Office Action Summary

09/933,169

DRUGA, LARRY A.

FIG. 2

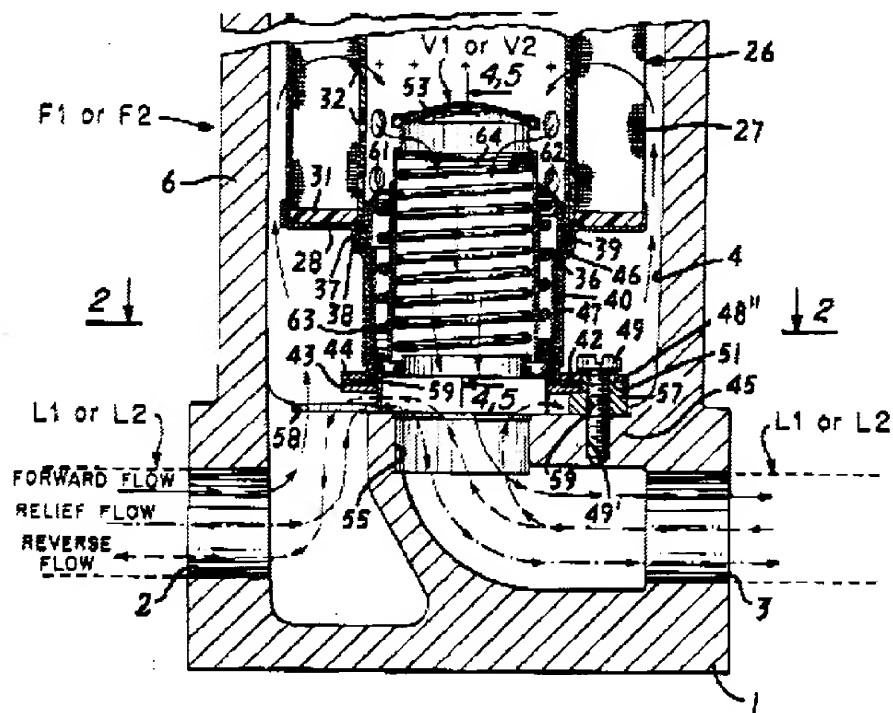
10. Claims 3 and 4 are rejected under 35 U.S.C. 102(b) as being anticipated by Cooper (U.S. 3,996,137). Cooper discloses a fluid filter that clearly anticipates claims 3 and 4. The bottom of figure 2 thereof is reproduced below.

The first, second, third fluid flows and the arrows thereof are shown above as the forward flow, relief flow, and reverse flow, respectively [as in claim 3], wherein the first flow path includes the

inlet 2, the space between the filter element 27 and the housing 6, the filter element, a central passage 35, and the outlet 3 [as in claim 4].

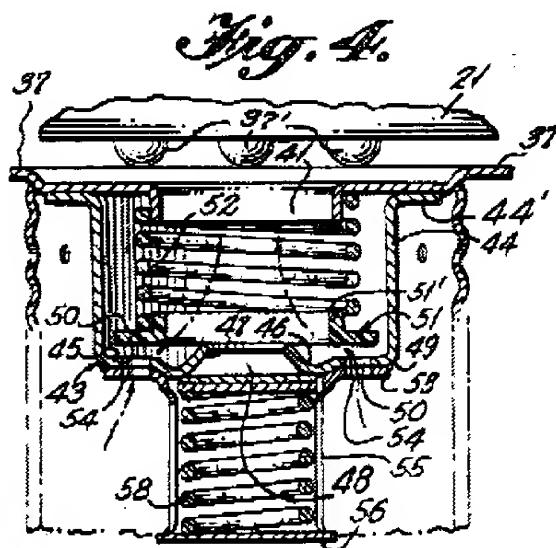
11. Claims 1-9, 11-12 and 15-17 are rejected under 35 U.S.C. 102(b) as being anticipated by ~~Hultgren~~ (U.S. 3,000,506). As shown in figure 4 reproduced below, ~~Hultgren~~ clearly anticipates claim 1.

As shown above, Hultgren discloses a first retainer 44 (or alternately 37 and attached wall 34), a first spring, a first disk 51, a second retainer 55, a second spring, and a second disk 57 (see figure 2), wherein the disks are operative to compress in opposite directions toward their respective retainers [as in claim 1].

As shown in figure 4, Hultgren also discloses the reverse flow bypass means to include a first disk 51 against a plurality of peripheral holes 50 in the end cap 45 operable to open toward the first retainer means (37) for fluid to bypass the media [as in claim 6].
